SERVICE BULLETIN

BE-001/54-2/2018

MODELS AFFECTED: SZD-54-2 „Perkoz”

SUBJECT: Additional securing of bushings on the wing's fittings as well as fitting of horizontal stabilizer.

Pic. 1 Identification of elements

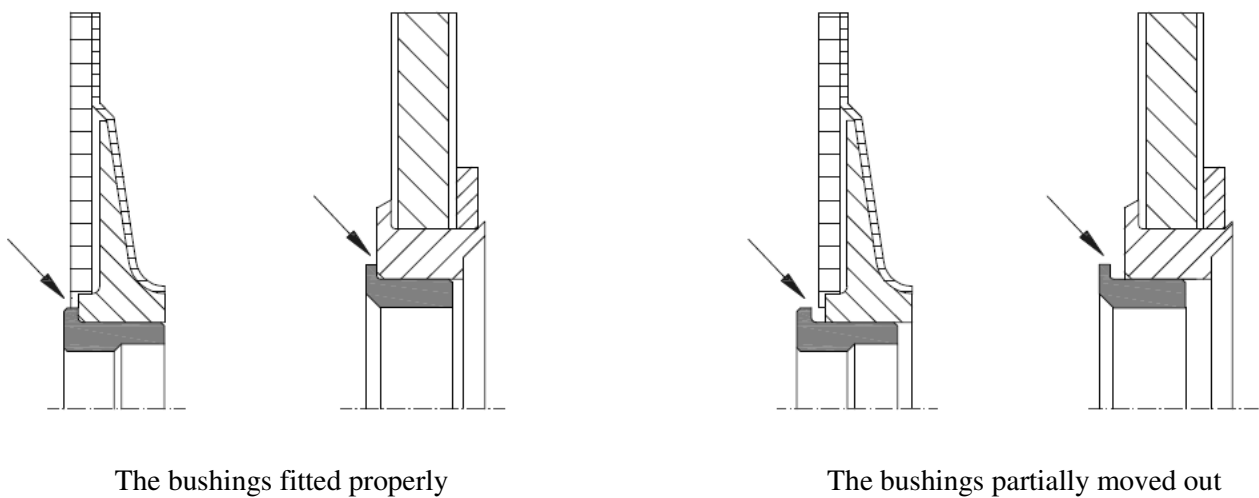
It has been found onto a few SZD-54-2 that the exchangeable bushings on the wings fittings and the horizontal stabilizer front fittings are able to move out from their nests (see Pic.1).

This is because of axial forces in joints, which may appear during in-flight operation and while derigging the sailplane.

In case of moving out in flight of both (or one) bushings from the wing-to-fuselage front fitting, it will have a negative impact onto quality of joints of assemblies, and will lead into perceptible and hearable playing of fitting, which is a flight safety issue.

Before next flight, derig the glider and check the mounting of bushings on the wing-to-fuselage front fitting nests, at root ribs on both wings, as well as at horizontal stabilizer fittings – see Pic. 1 and Pic. 2.

Pic. 6 Positioning of access openings for securing ring

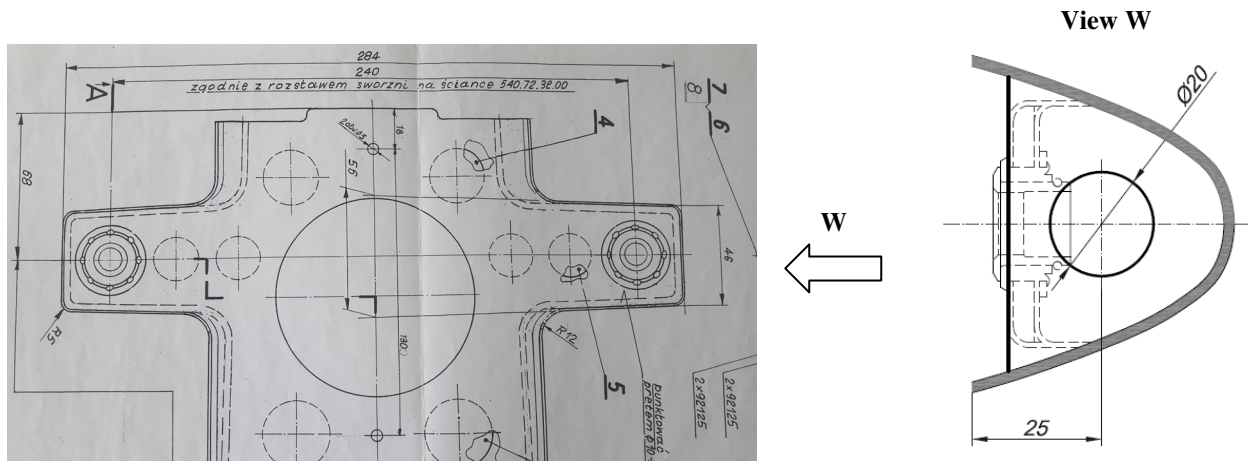
- mark and carefully cut off the access openings $\phi 20$ mm in the walls, as shown on Pic. 6:

- push in the bushings and secure them with securing rings (item1, Pic. 5);
- cover the access openings with a white tape or laminate acc. to Chapter 17 of TSM.
